**Brisbane Central Business District Bicycle User Group
(CBD BUG)**

The CBD BUG is writing to you regarding the proposed Albert St Plaza to be provided by the Cross River Rail Authority (CRRRA) to address three matters, the CRRRA consultation process, the design of the Albert St Plaza and CRRRA's failure to reference existing planning documentation. This letter has been prompted by the interactive 3D image CRRRA released on Facebook on 23 March 2023 (refer Figures 1 & 2)

Albert St Plaza Design

Figure 2

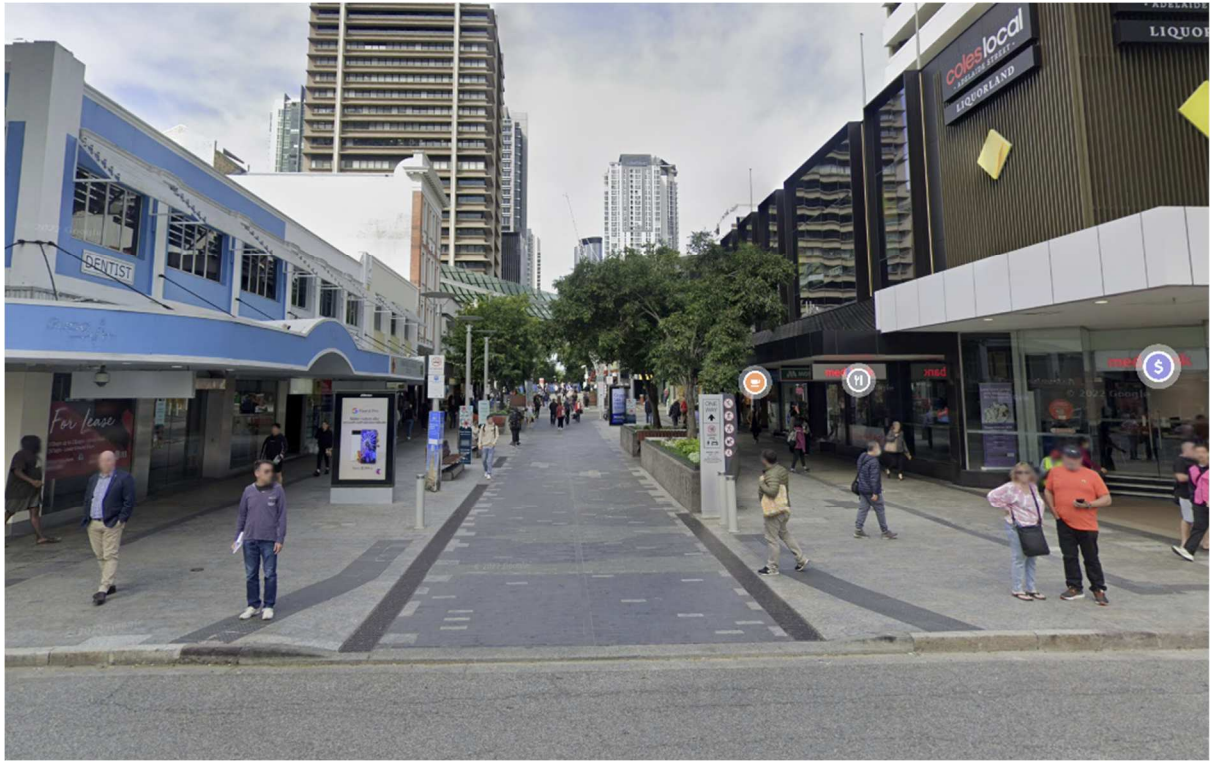
This is not how the space is currently proposed. It has been specifically designed to ensure conflict as no user group has been provided with clear visual cues of where they should be. This contrasts with the shared zone of Albert St where motor vehicles accessing Burnett Lane turn off Adelaide St (Figure 3). In this location it is still shared space but it clearly identifies where motor vehicles are to travel. It is perplexing to the CBD BUG why a similar

approach cannot be applied to the proposed Albert St Plaza. Naturally the clear visual cues of where bicycle movements are recommended to be do not need to be as wide but it should be just as clear.
